KWM-380 TRANSCEIVER (622-5093-101)  
HF-380 TRANSCEIVER (622-3580-101)  
RECEIVER-EXCITER CIRCUIT CARD A3 (638-6908-001)

SERVICE BULLETIN NO 1

PRODUCT IMPROVEMENT

P/O Receiver-Exciter Circuit Card A3.  
Figure 1 (Sheet 2)

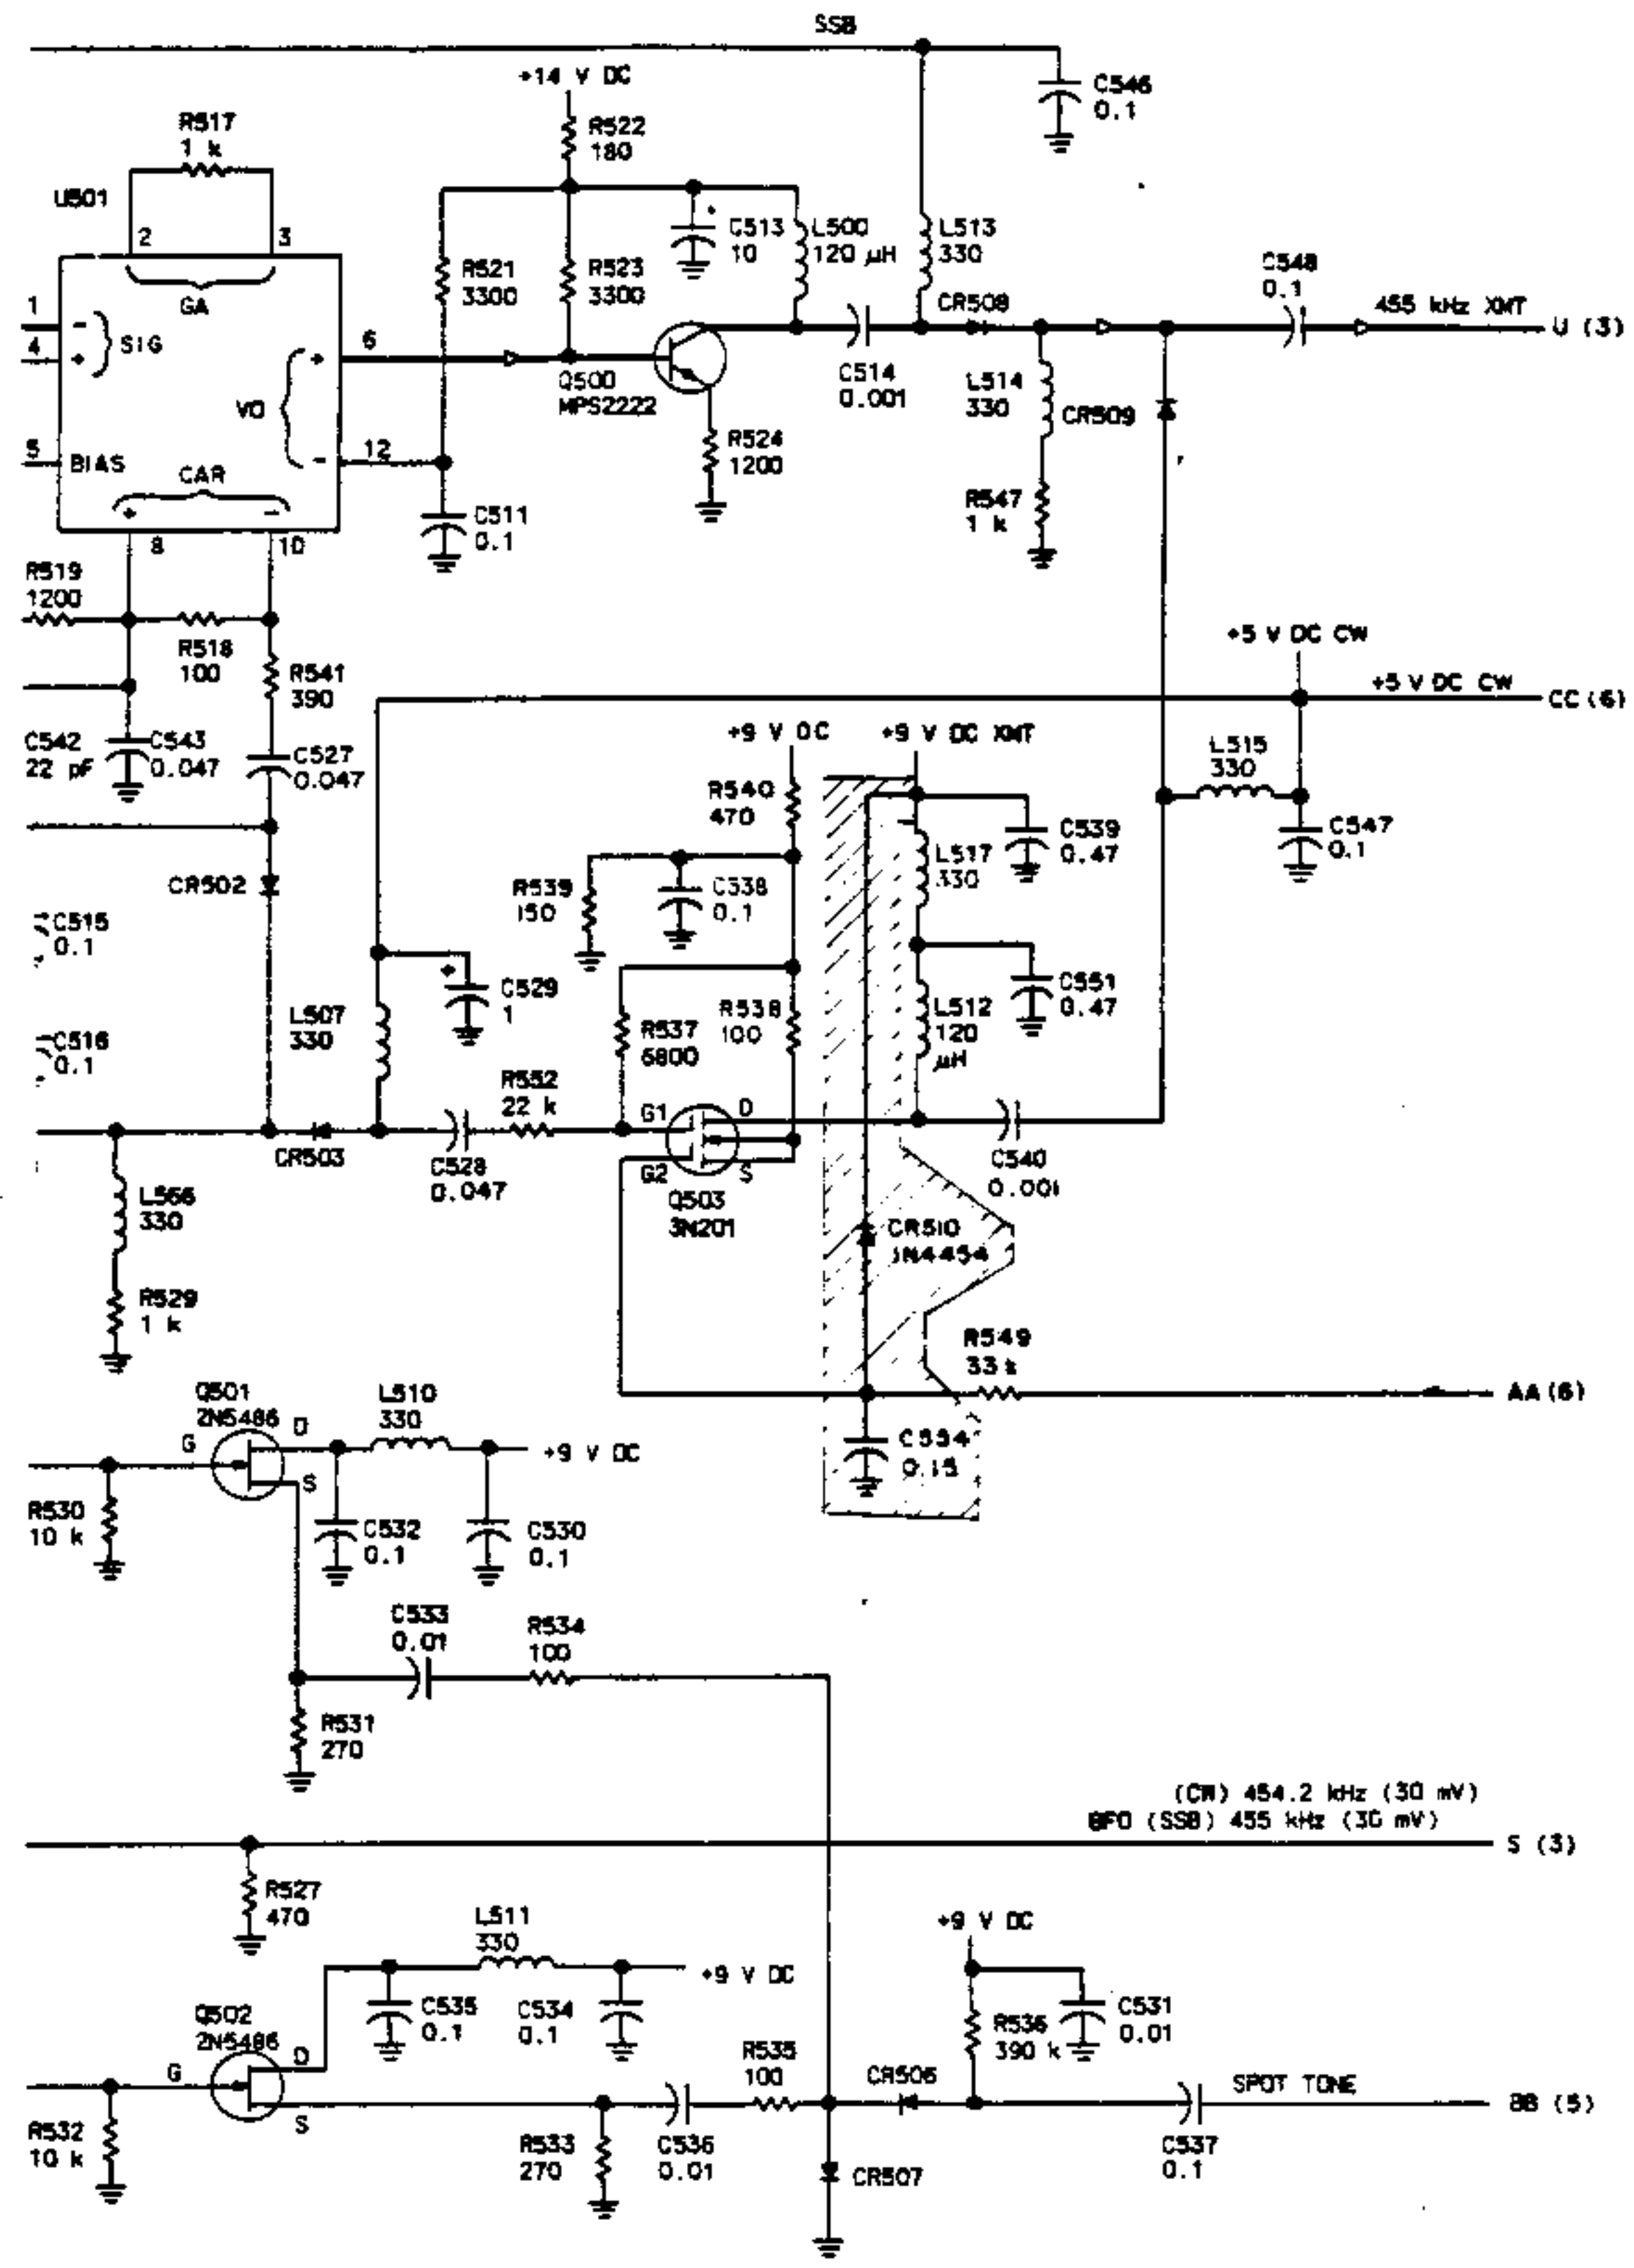
- H. Refer to figure 1, detail M, for location and install five square pins (372-2601-045). Lift component leads, as necessary, and reconnect the leads to the pins after the square pins are installed.

- K. Install a jumper wire (428-0282-050) from the square pin at the bottom lead of R922 to the thru hole to the right of U913-9.

- L. Install a jumper wire (428-0282-050) from the square pin just below R968 to the thru hole to the right of U913-8.
- M. Remove 47- $\mu$ F capacitor C902 and replace it with a 10- $\mu$ F capacitor (184-9102-610).

- N. Install 0.1- $\mu$ F capacitor C988 (913-5019-440) from the square pin at the bottom lead of R925 to the square pin below R968.
- O. Install 1.5- $\mu$ F capacitor C989 (184-9102-800) with the positive lead connected to the square pin at the right-hand lead of R926 and the other lead connected to the square pin at the bottom of R925. Refer to figure 1, detail M, section D-D.
